**TOWN OF OCEAN RIDGE
PLANNING & ZONING REGULAR MEETING
AGENDA**

**May 19, 2026 at 9:00 AM
Town Hall - Meeting Chambers**

To:	Planning & Zoning Board Members
From:	Corey O’Gorman, Town Planner
Meeting Date:	May 19, 2026
Subject:	7 Harbour Dr N – Development Plan Review

**PLAN REVIEW REPORT
5920 N Ocean Boulevard
05/06/2026**

Sheet: north and south elevations

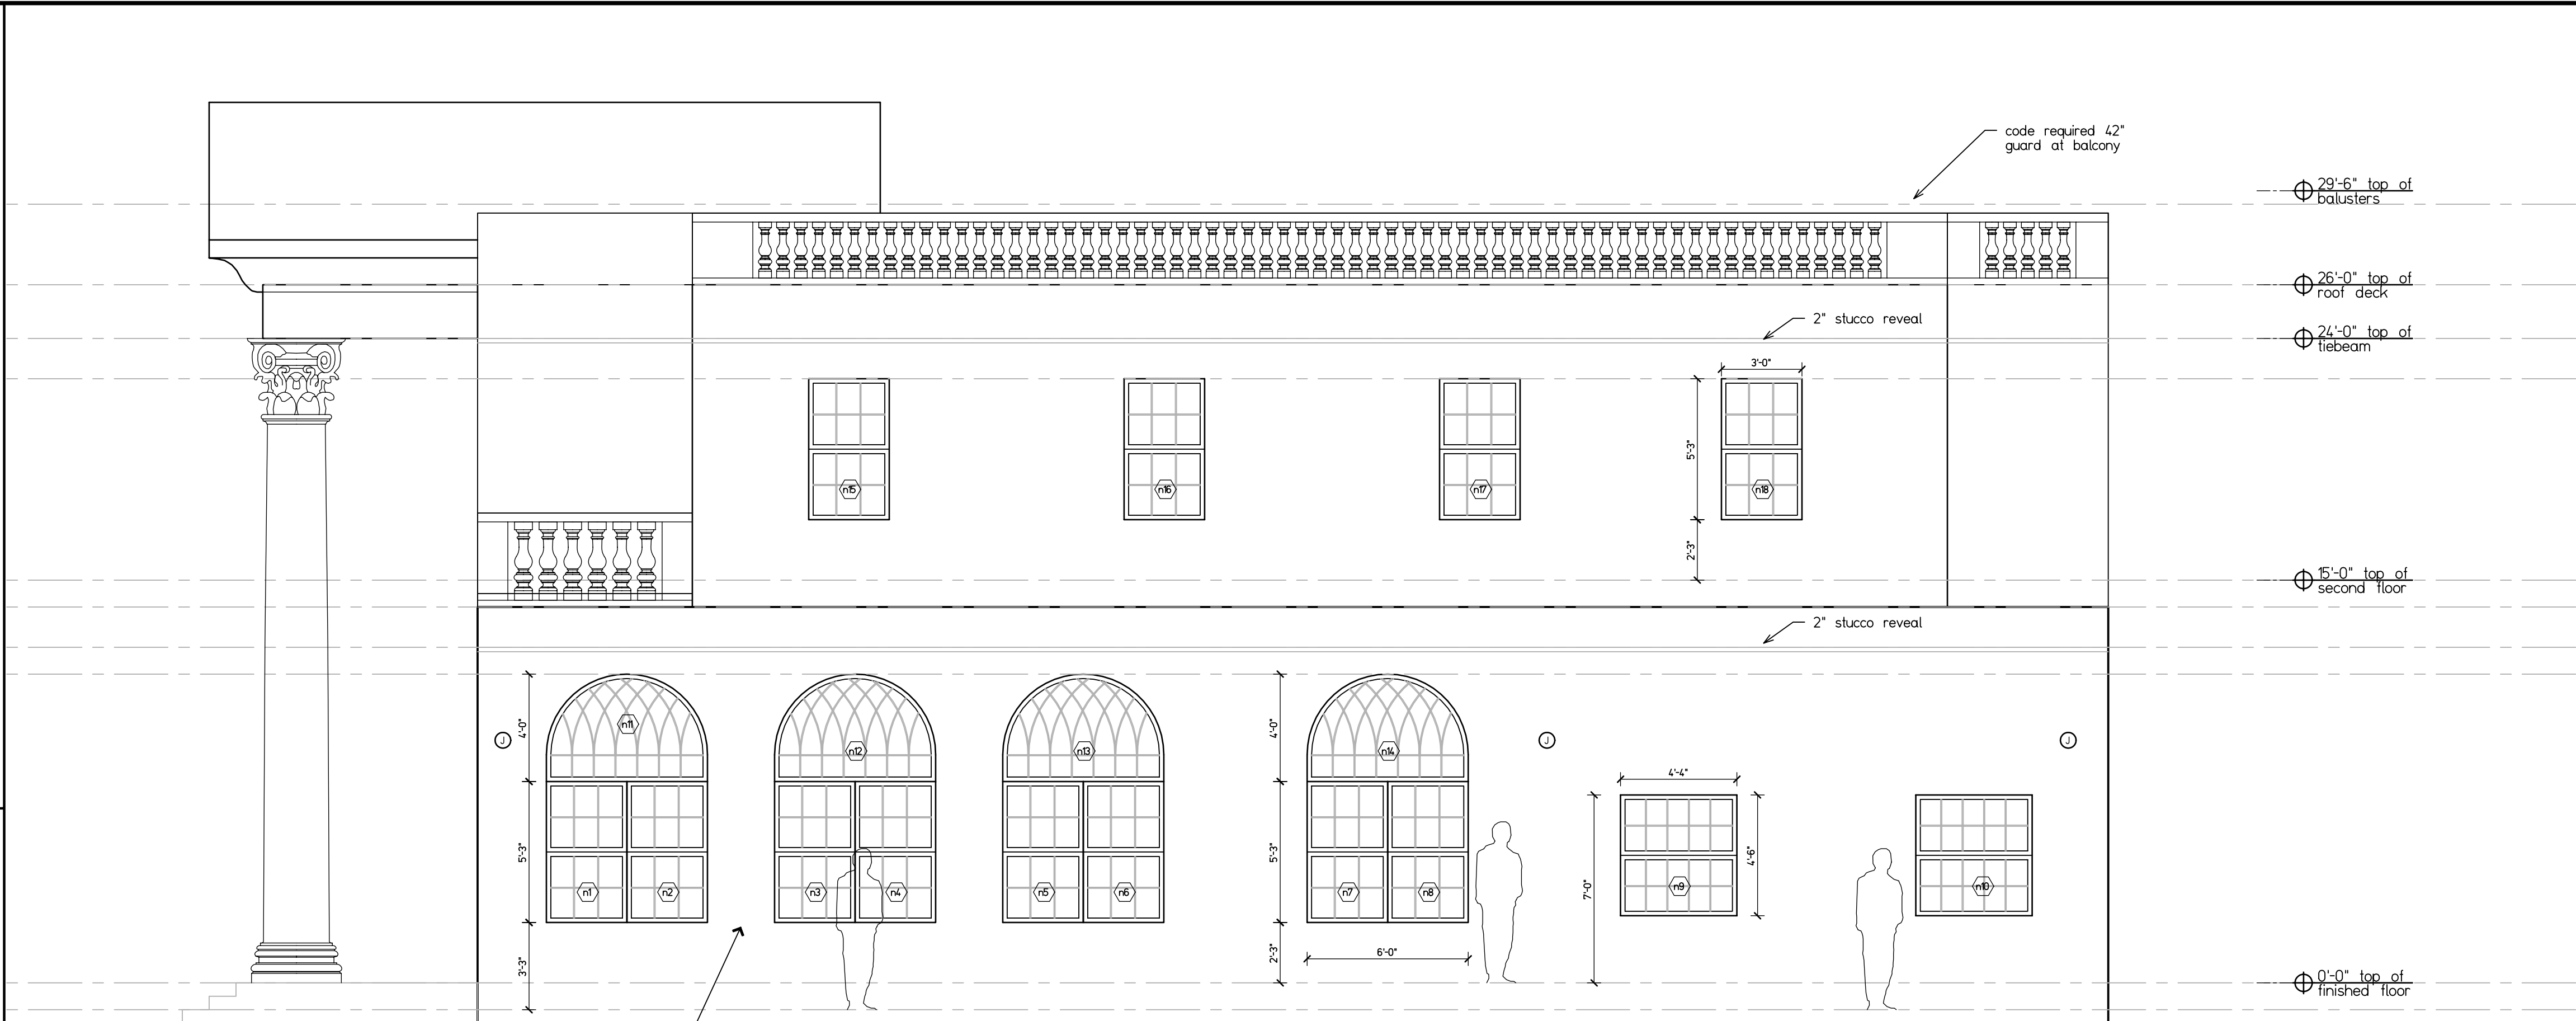
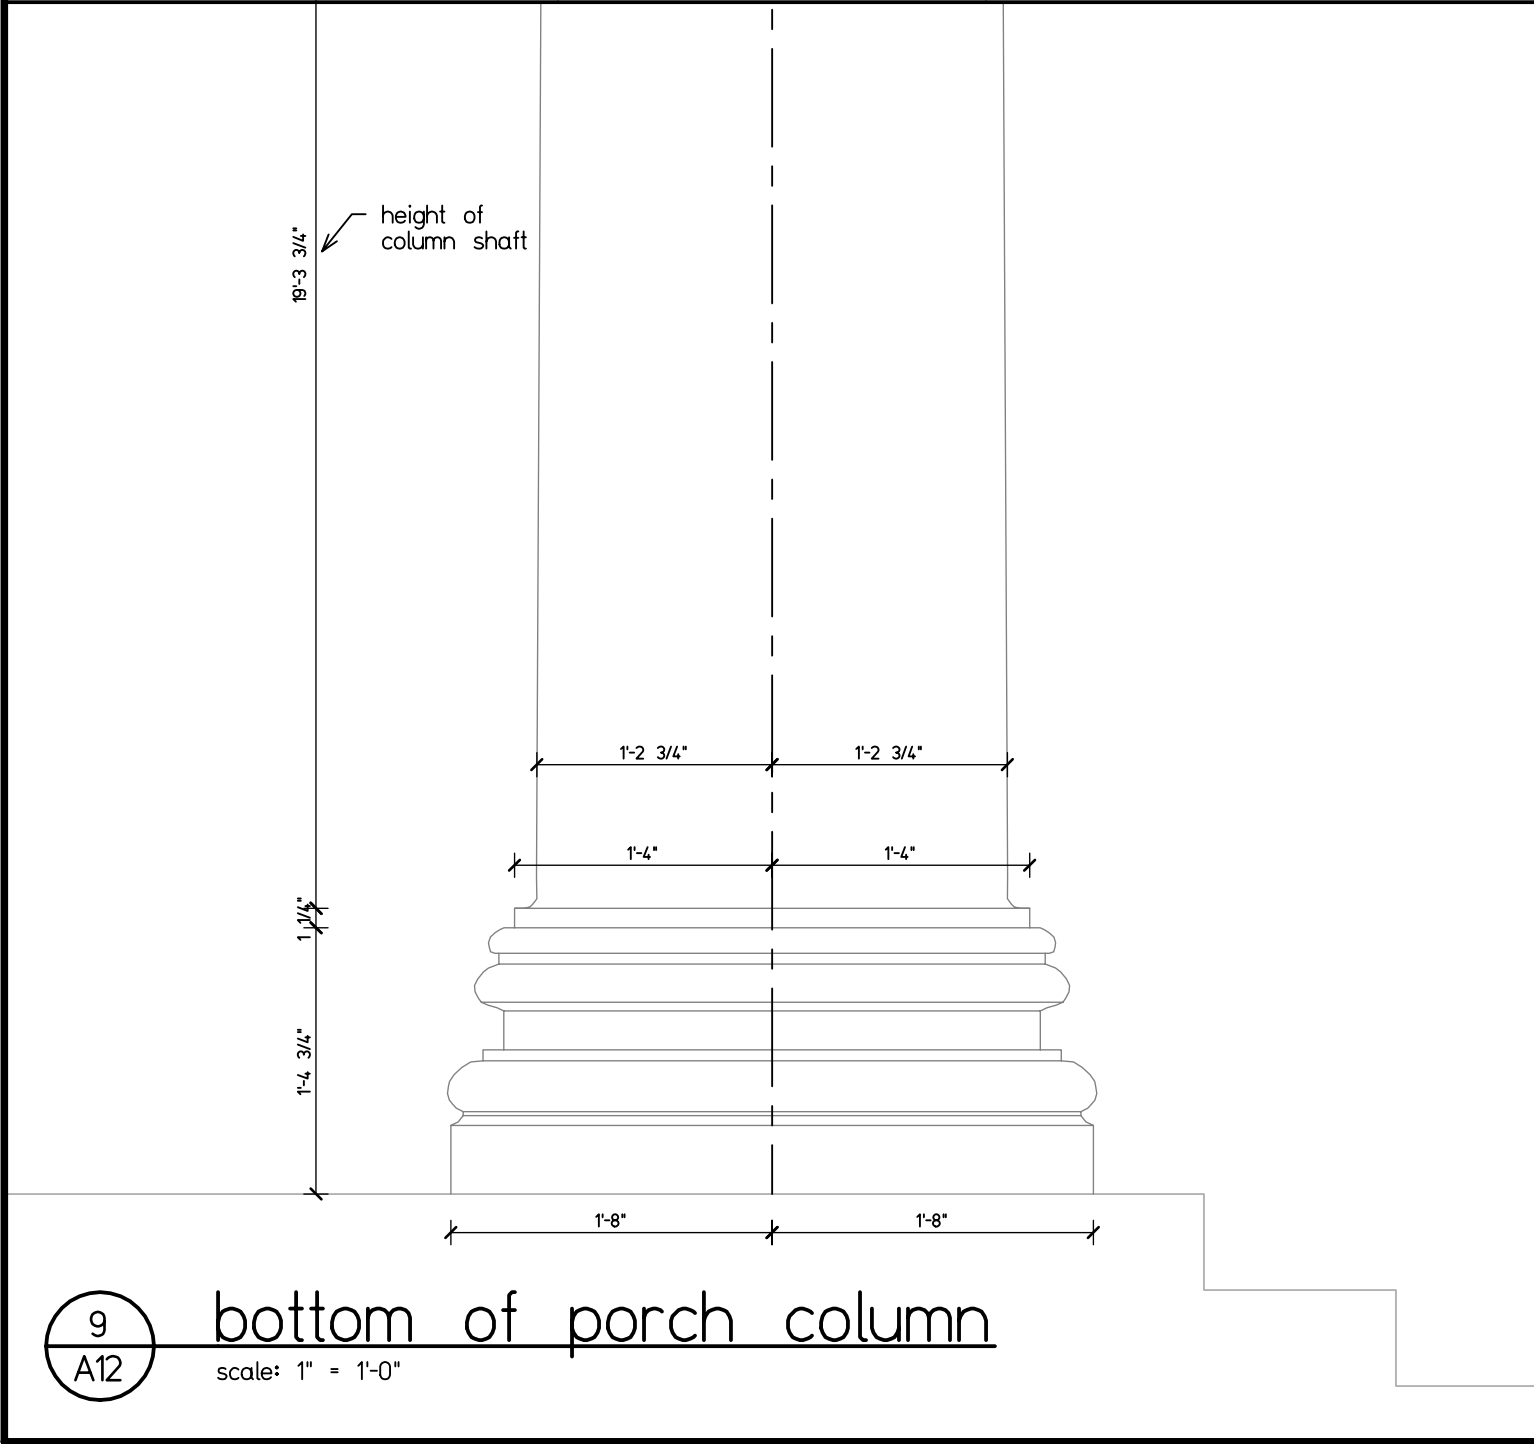
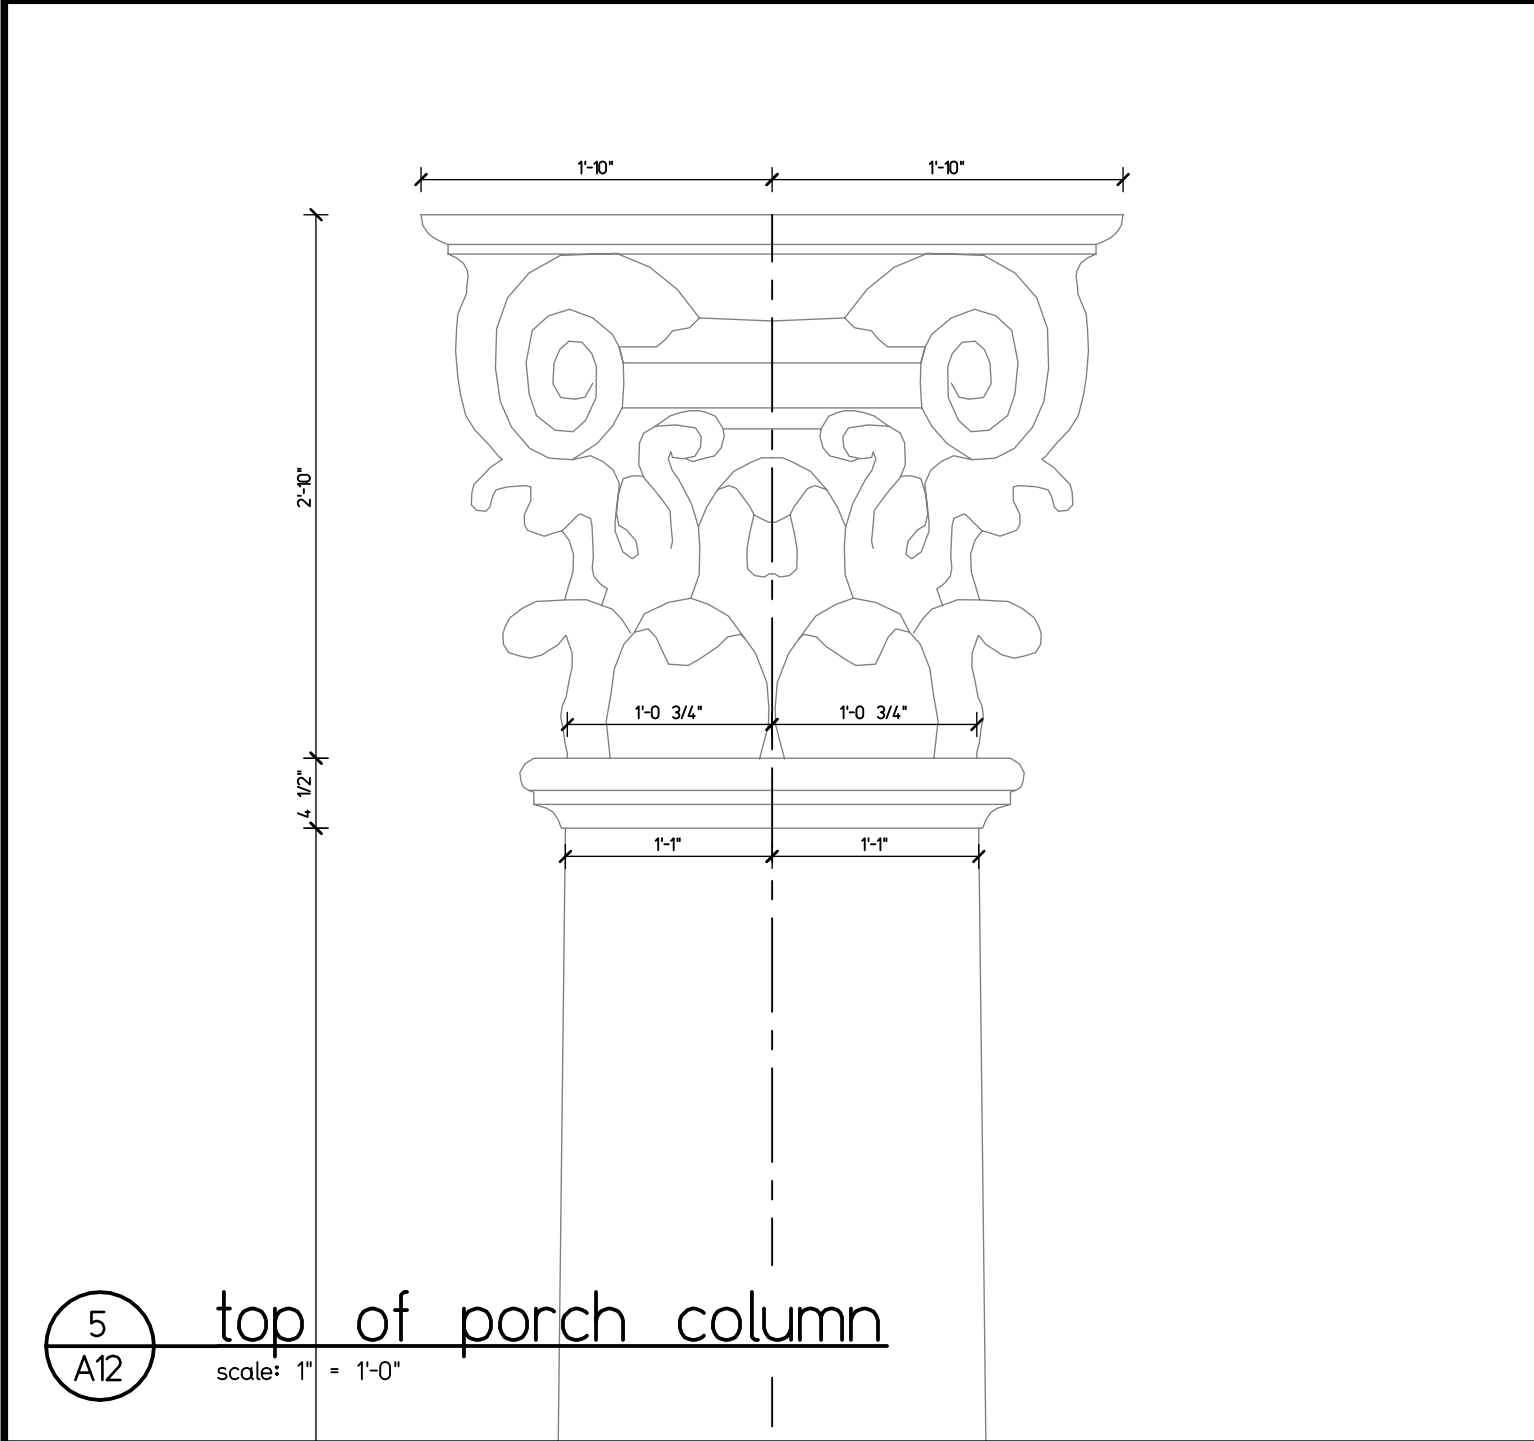
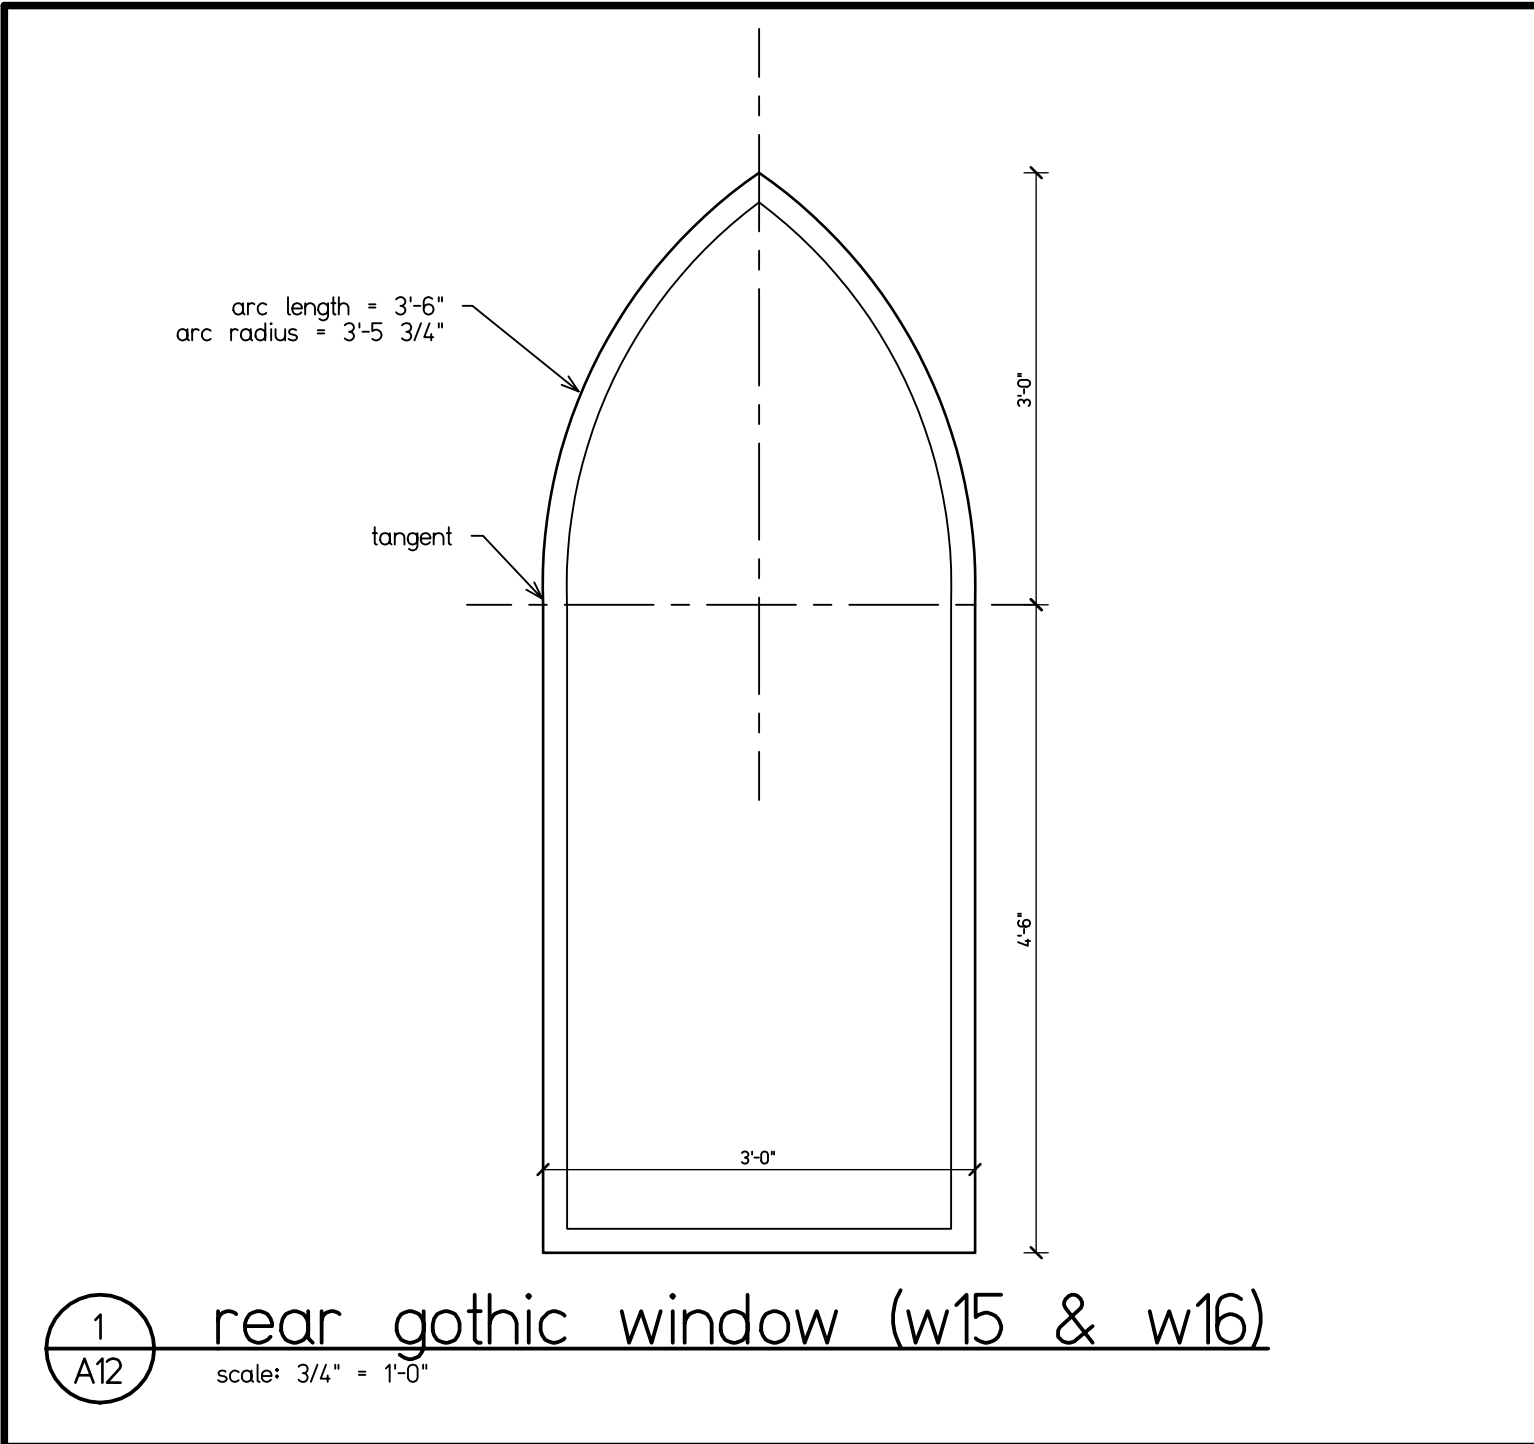
Comment: Please revise elevation sheets A11 and A12 to provide the calculations necessary to ensure compliance with the 15% requirement.

Comment: Please revise sheets A11 and A12, and other sheets as applicable to comply with the maximum height requirements in this code section.
